Re: Case #208-18-GRD-21; Proposed Self-Storage Facility with Solar; 17 Sterling Drive; Modification to Approved Project Application.

# Modification to Approved Project

Case # 208-18-GRD-21 Property Address 17 Sterling Drive
Type of project: Site Plan X ; Subdivision ; Line Adjustment ; Other;
Project name Packy Investment Properties Self-Storage Facility
Date of original Planning Board approval February 6, 2023
Description of modification: The four proposed solar trackers that were proposed in the wetlands were revised to place them
at least 25 feet from the wetlands. The plans were also revised to remove all wetland impacts and relocate the proposed temporary
access path and adjusted the temporary impacts to the Conservation Overlay district.
Applicant Name; Packy Investment Properties, LLC c/o Packy Campbell
Mailing Address 123 Washington Street, Rochester NH 03867
Phone Number: 603-765-9101 Email Address: packyc@rsarealty.com
Please note: Modifications are reviewed by the Planning Board but no public hearing is held and n notices are required. (In contrast, projects, which are considered to have a potential impact upoabutters, are considered amendments for which notice and a p

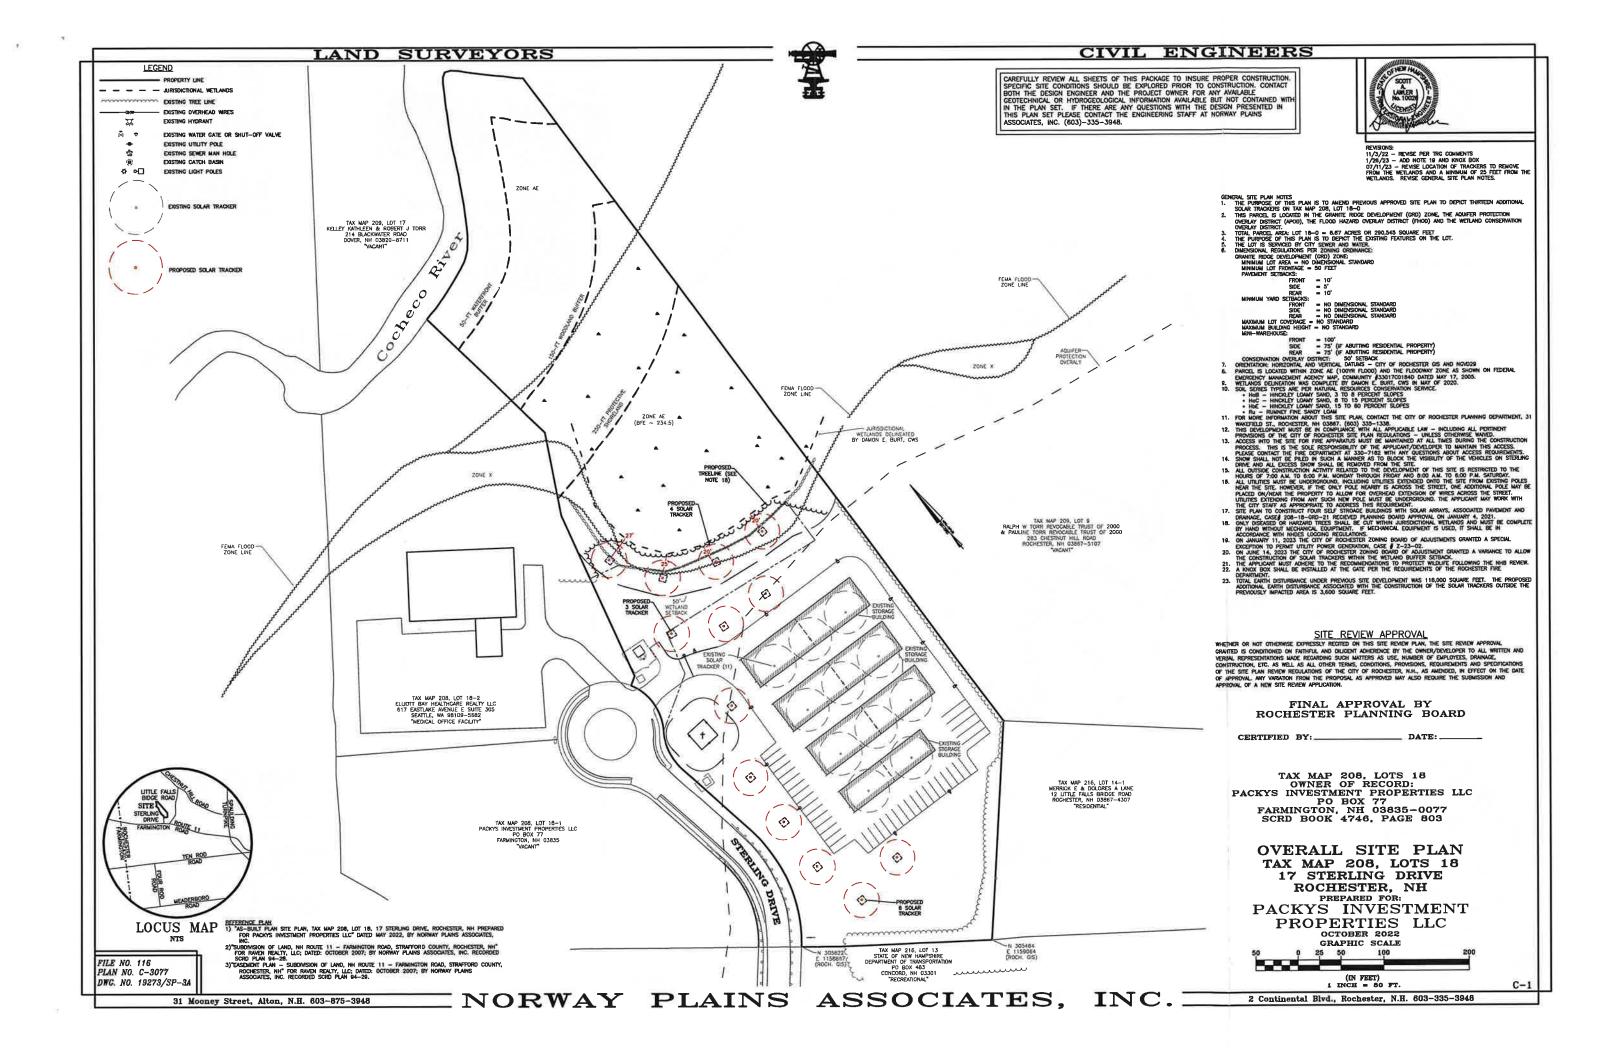
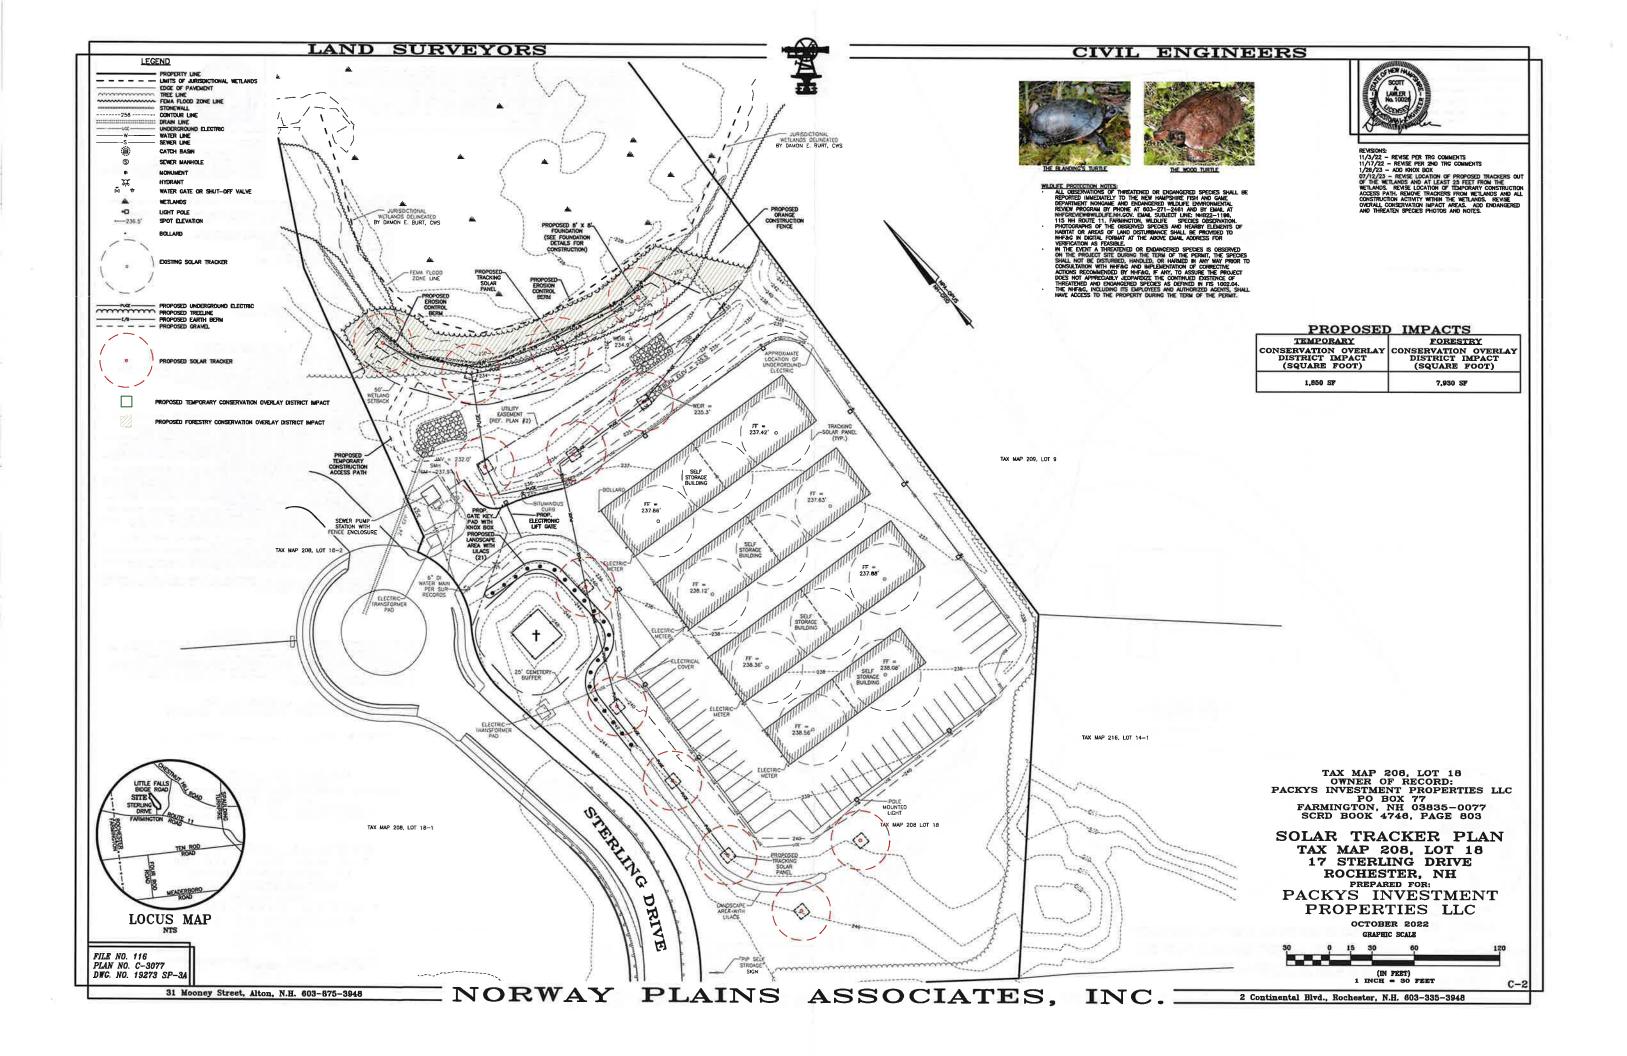
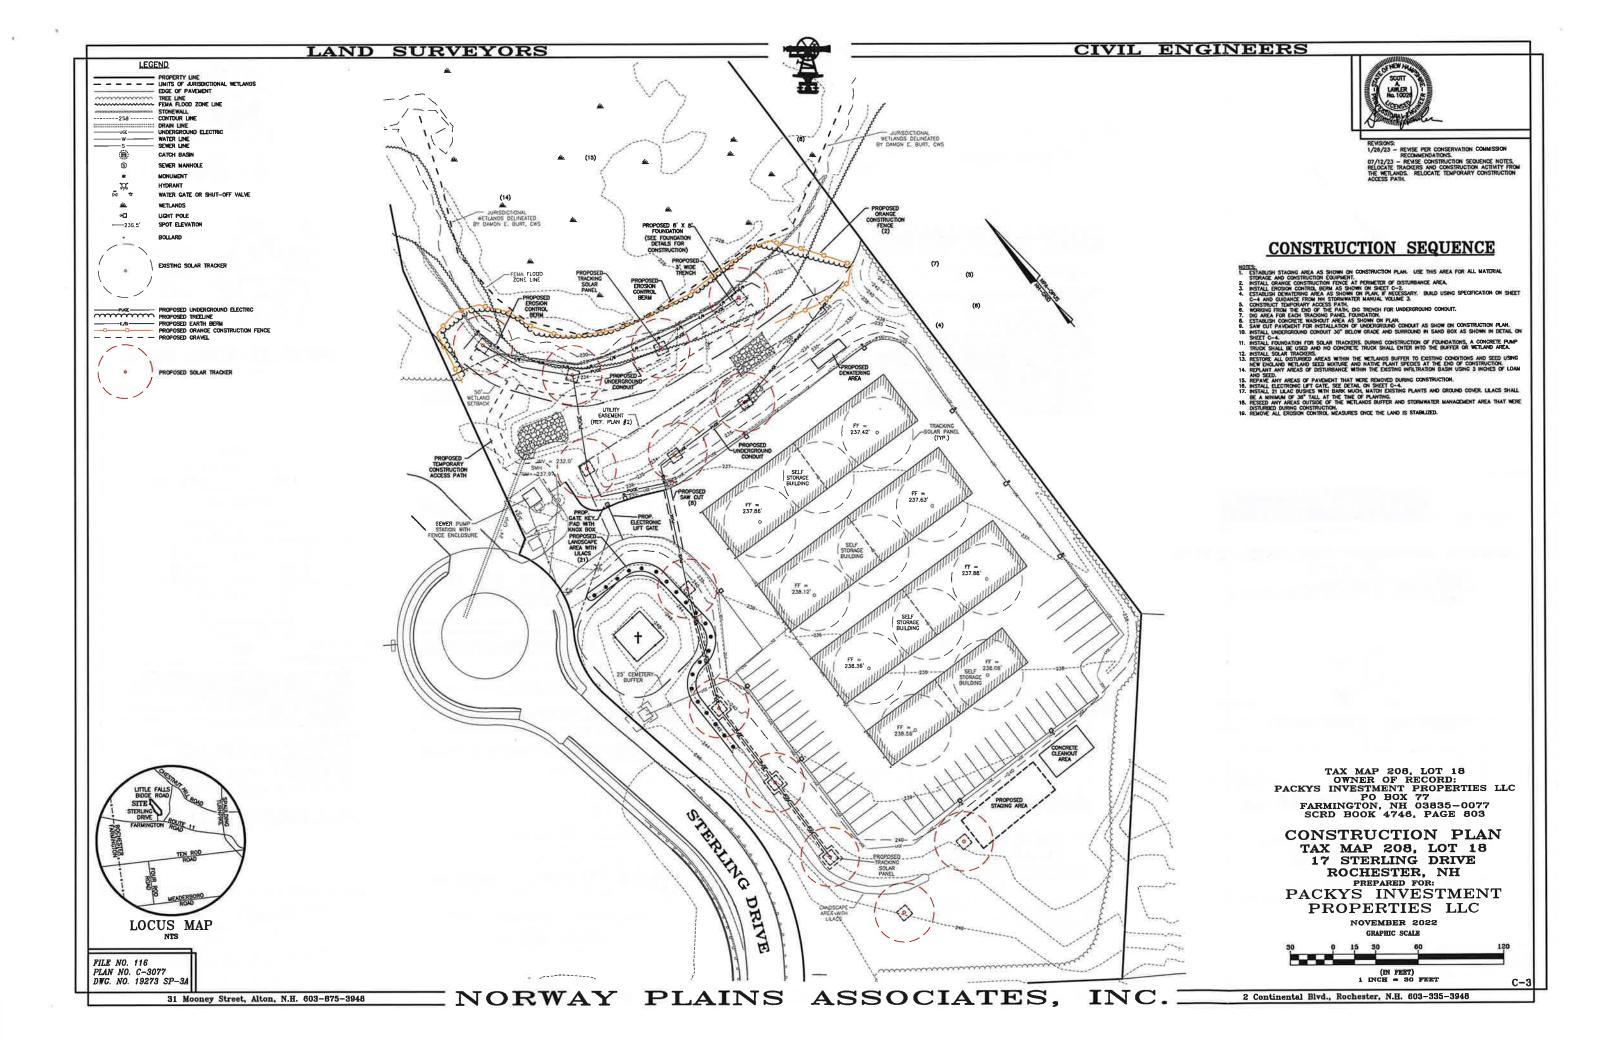
- Four of the six solar trackers that were in the wetlands are relocated a minimum of 25 feet from the wetlands along the existing stonewall. By placing the trackers 25 feet away, it would ensure the solar panels would not rotate over the wetlands and cause any impacts to the wetlands. This resulted in shifting the temporary maintenance path from one side of the site to the other side. The overall temporary impacts square footages to the CO district were revised accordingly.

- The other two of the six trackers are relocated to the southwesterly corner of the development. They are placed such to not have any impacts on the operation of the site.

- The three trackers that are located in the stormwater management system were shifted to place them in the berm between the infiltration basin and the sediment forebay. The placement to the berm was to reduce the disturbance to the established infiltration basin and to provide more separation to the other proposed trackers.
